Environmental Impacts of the Proposed Heartland Transmission Project

John Kristensen
Biologist, Natural Historian
Vice President Technical, RETA

1.0 Introduction

Figure 1 Ponds On Preferred Route

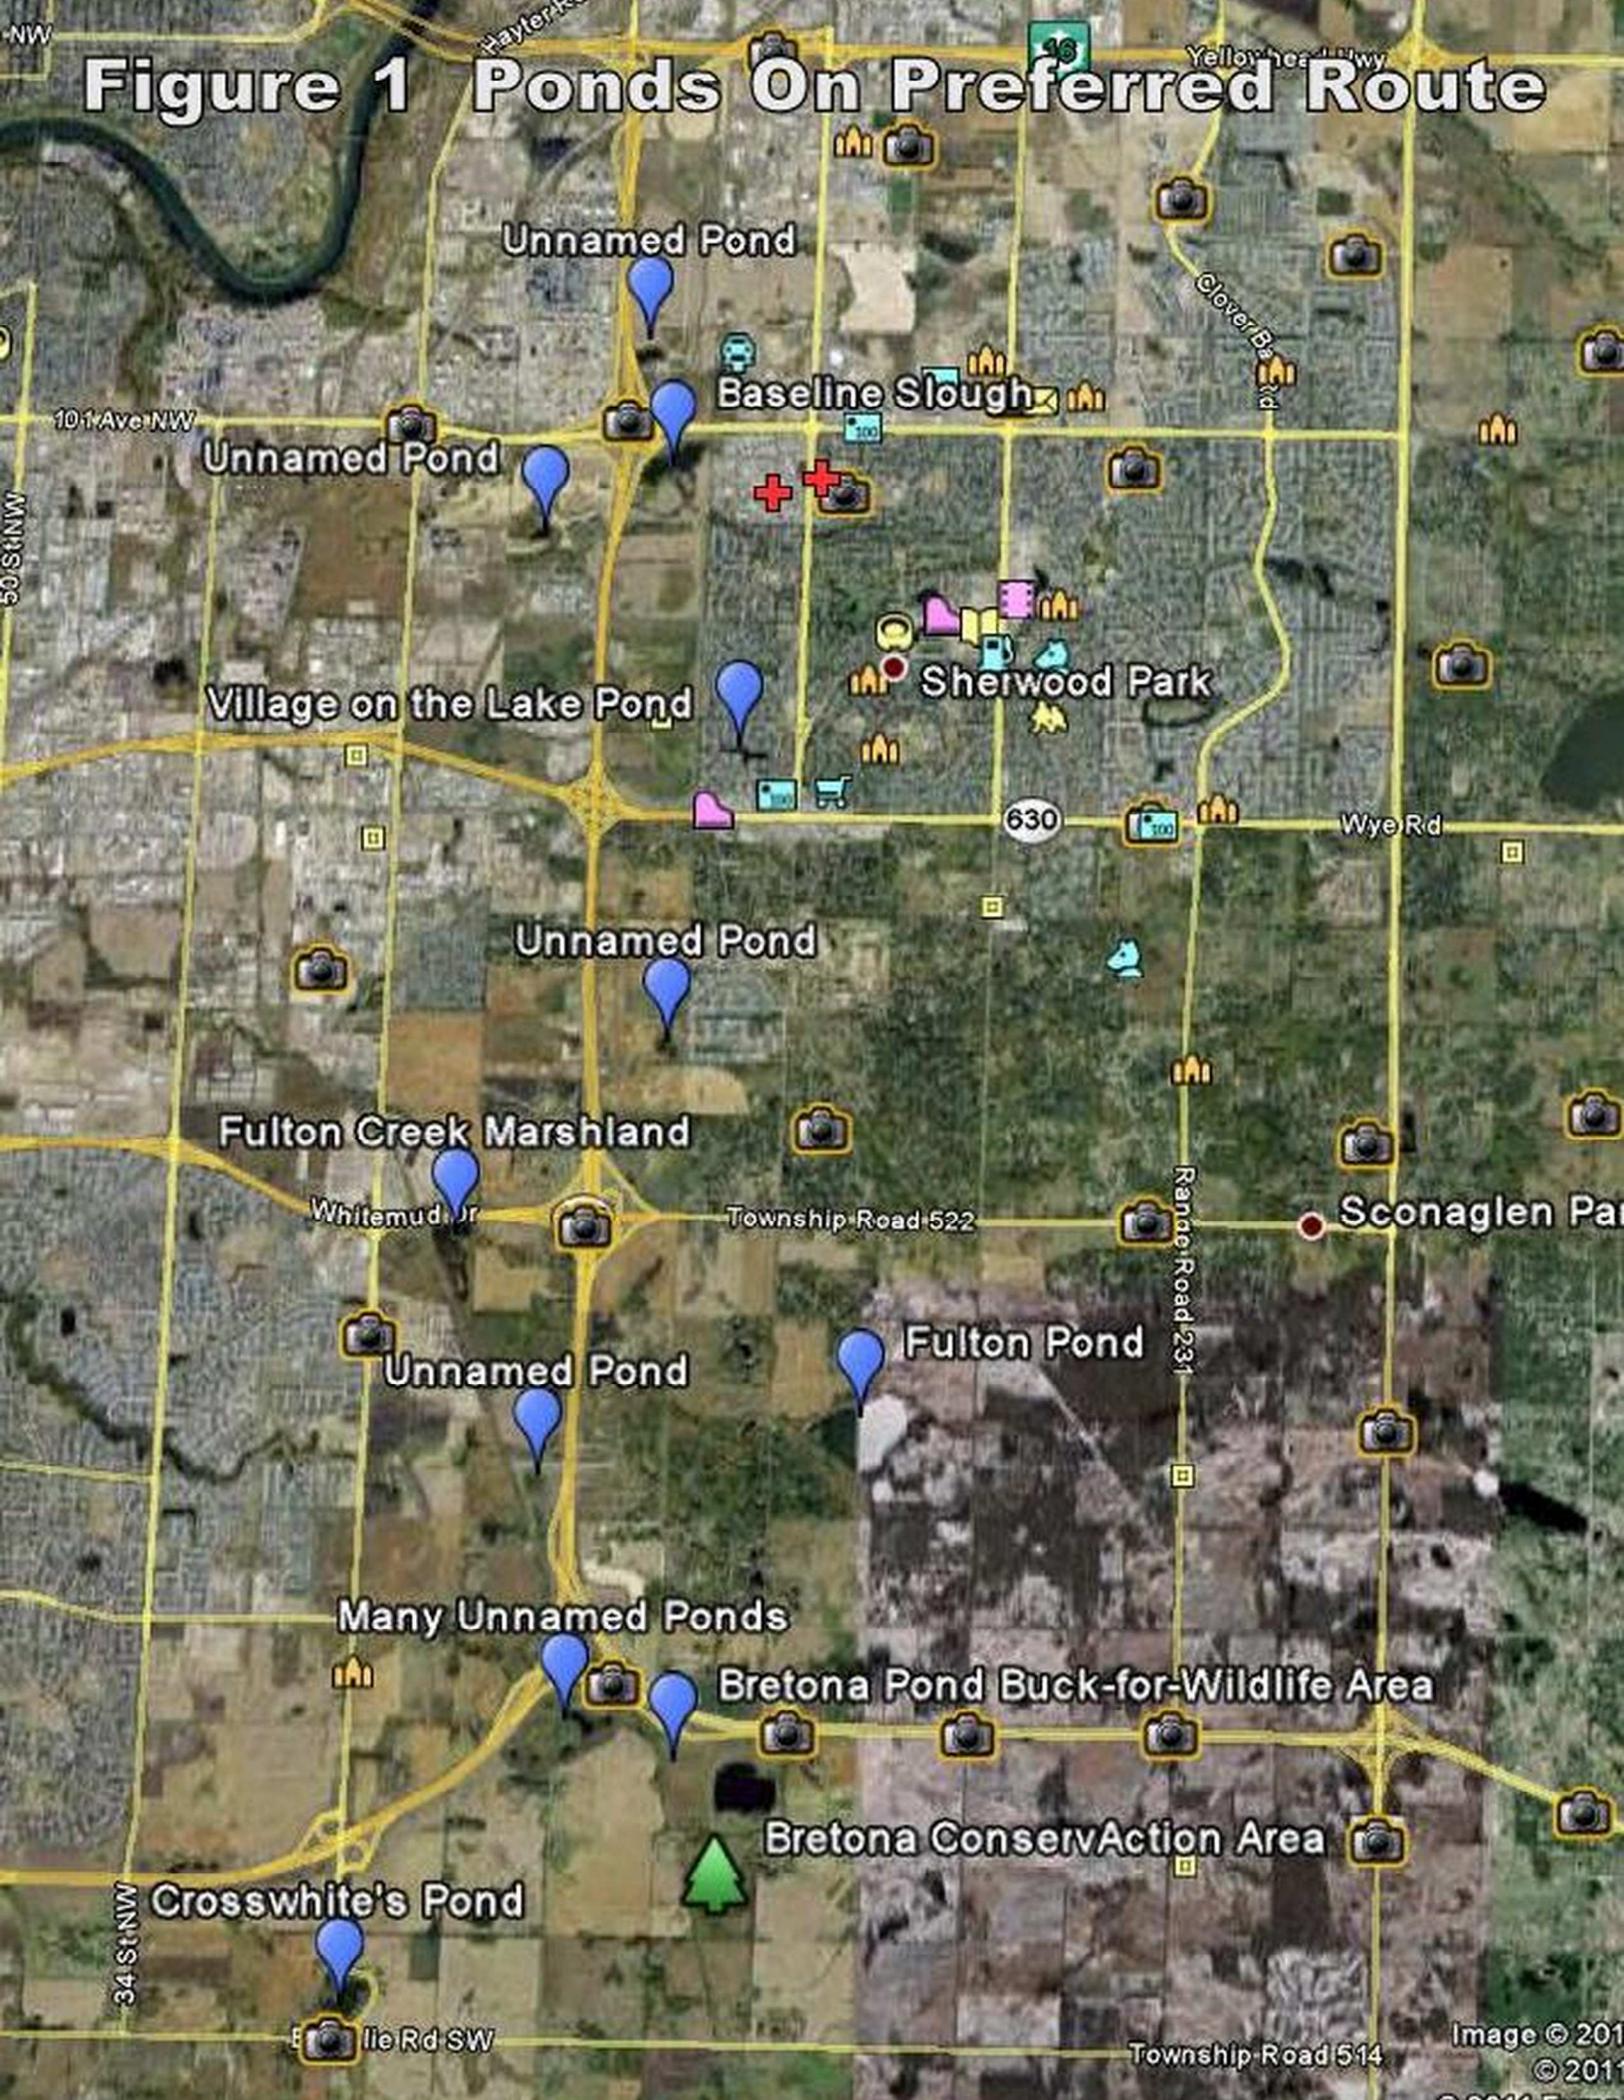
Some of the waterbodies and natural spaces in this area that are important habitat for waterfowl and many other bird species, and that would be directly impacted by an overhead Heartland power line in the preferred route, include: North Saskatchewan River, Sturgeon River, Strathcona Science Provincial Park, Bretona Pond Buck-for-Wildlife Area, Mill Creek, Fulton Creek Marshland, Fulton Pond, Fulton Creek, Crosswhite's Pond, Bretona ConservAction Area, Baseline Slough, and many other ponds, sloughs and wetland complexes (Figure 1).

The Bretona Pond wetland complex is significantly larger than shown and considered in the facility application. Crosswhite's Pond at the Ellerslie Road–17th Street intersection, Fulton Pond just east of the preferred route and south of Whitemud Freeway, Fulton Creek, Fulton Creek Marshland, plus many small and medium-sized standing waterbodies within 800m of the proposed Heartland line, most of which are essentially ignored within the facility application, are all part of the Bretona Pond wetland complex (see Figure 1). Collectively, all of these ponds and wetlands attract thousands of waterbirds.
